### **Meadowbank and Whale Tail MDRB Report No.29**

Report No 29  
Meadowbank Mine Dike Review Board (MDRB)  
Site visit August 24<sup>th</sup> to 26<sup>th</sup>, 2021 and Conference call of November 22<sup>nd</sup>.

## **RESPONSE TO COMMENTS, MEADOWBANK DIKE REVIEW BOARD No.29 – MEADOWBANK REPORT**

Photo No. 3 Meadowbank TSF, sealant spreading

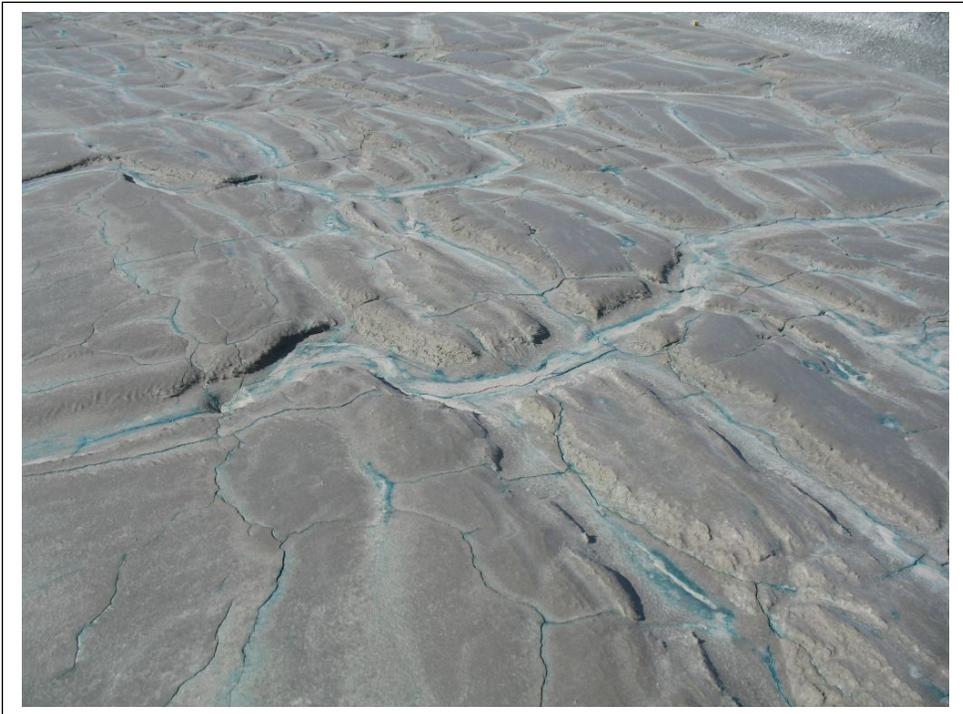
In anticipation that the capping will not be immediate, AEM has embarked on a surface sealing exercise to suppress the potential for dust generation at certain times of the year. (Photo Nos 3, 4 and 5)

MDRB#29-5	Tailings Management	2021	AEM may wish to initiate a longer-term tailings conceptual storage options assessment, considering a range of potential Life of Mine (LOM) storage requirements from the Meadowbank Mill. Although there is currently a significant amount of capacity/flexibility with the use of exhausted pits for tailings storage, an assessment of the long-term potential storage scenarios would allow for more confident planning and possible commencement of progressive reclamation activities for the TSF and select Pits.	The remaining capacity of the in-pit has been assessed. Following this exercise AEM is planning to initiate a MAA process to identify alternate strategies for tailings storage at the Meadowbank Complex from a long term perspective.	Not Started	Dec-22
MDRB#29-6	Tailings Management	2021	The impact of the dust suppressant on the behaviour of the tailings beach behaviour and runoff characteristics should be observed/monitored. Specifically of interest is the impact on crack development and subsequent healing (densification) and amount of runoff versus infiltration into the tailings beach/cracks.	The surface of the tailings will be examined at next freshet from drone images to determine if the dust suppressant is impacting the tailings surface.	Not Started	Aug-22
